Owner Change Order (OCO)

Project Name: Brookline - Driscoll
School
Gilbane Job No.: J08864.000

OCO: OCO-0005

Scope Of Changes: OCO 005 Misc Changes

FIRST FLOOR BELOW SLAB - PLUMBING - SKPA 1.14

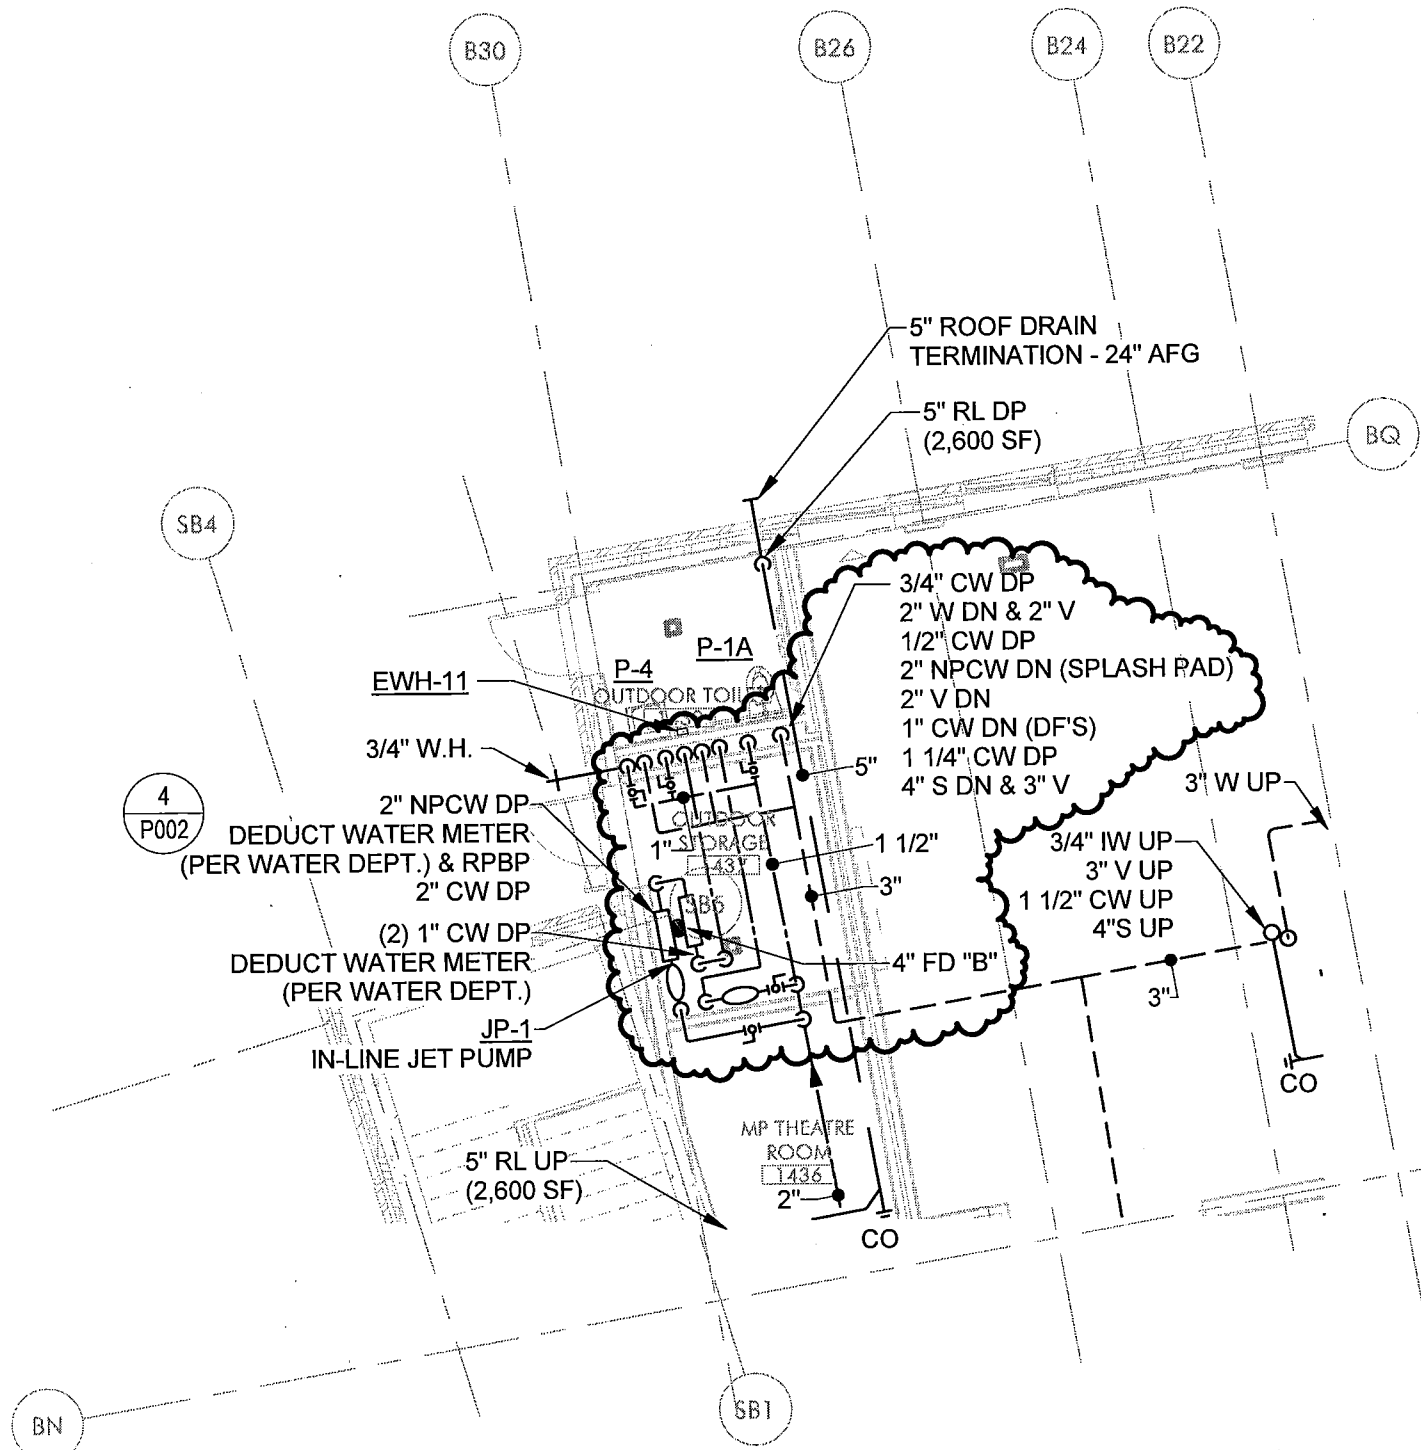
DESCRIPTION: This ATP represents request to proceed on Time & Materials to perform work as outlined in RFI #65 added a 4" FD B in outdoor storage 1437, including vent and trap primer. Sketches SKAP 1.14 and SKAP 1.15

Plumbing serving the Splash Pad is located in Outdoor Storage 1437. The 2" Backflow Preventer has an air gap that needs to be piped to a floor drain.
Should a Floor Drain be added to this room? If yes, what size?
Note: A trap primer would also be necessary.

Provide 4"FD "B" in Outdoor Storage 1437, including vent and trap primer. Refer to attached Plumbing Sketches SKAP1.14 & SKAP1.15, dated 9/28/21.
